Access Compliance Report

Public Rights-of-Way

Intersection ID: 9648	Main Street: TIMBERBROOK_DR	Cross Street: TUCKASEEGEE_RD	Location: NW
ADA ID: 515AB8A161F6	Ramp Type: Perp	Initial Pass/Fail: Fail	Overall Compliance: No
		Severity Score: 1.25

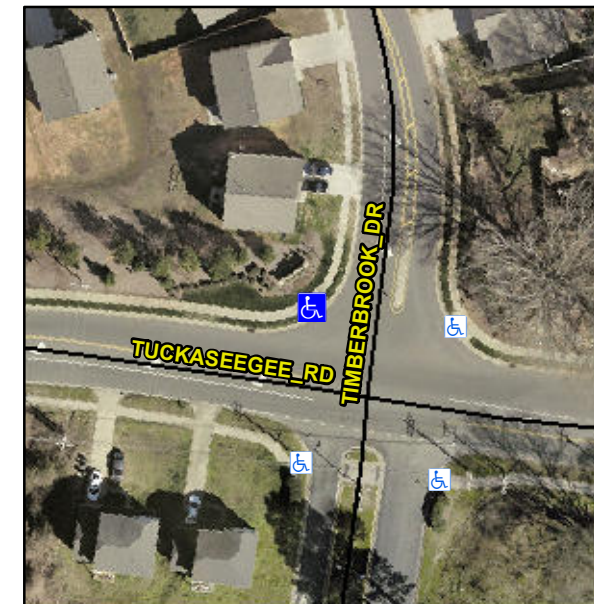
Not Found, R304.5.3

Compliance	Description	Data	Compliance	Description	Data
N/A	Ramp Length (in)	49.0	Yes	Ramp Slope (%)	5.4
Yes	Ramp Width (in)	54.0	No	Ramp XSlope (%)	2.4
N/A	Flare Type LT	N/A	N/A	Flare Type RT	N/A
N/A	Flare Slope LT (%)	N/A	N/A	Flare Slope RT (%)	N/A
N/A	Flare Traversable LT?	N/A	N/A	Flare Traversable RT?	N/A
N/A	Landing Length (in)	N/A	N/A	DWS Provided?	N/A
N/A	Landing Width (in)	N/A	N/A	DWS Contrast?	N/A
N/A	Landing Slope (%)	N/A	N/A	DWS Length (in)	N/A
N/A	Landing X Slope (%)	N/A	N/A	DWS Full Width?	N/A
N/A	Landing Curb? (Y/N)	N/A	N/A	DWS Offset (in)	N/A
N/A	Shared Landing?	N/A			
N/A	Gutter Ponding?	N/A	N/A	Gutter Slope (%)	N/A
N/A	Gutter Lip Ht (in)	N/A	N/A	Gutter X Slope (%)	N/A
N/A	Painted X Walk1?	No	N/A	Painted X Walk2?	N/A
	X Walk 1 Direction	To E		X Walk 2 Direction	N/A
N/A	X Walk 1 Width (in)	N/A	N/A	X Walk 2 Width (in)	N/A
	X Walk 1 Slope (%)	2.1		X Walk 2 Slope (%)	N/A
	X Walk 1 X Slope (%)	1.3		X Walk 2 X Slope (%)	N/A

Remove & Replace Entire Ramp.
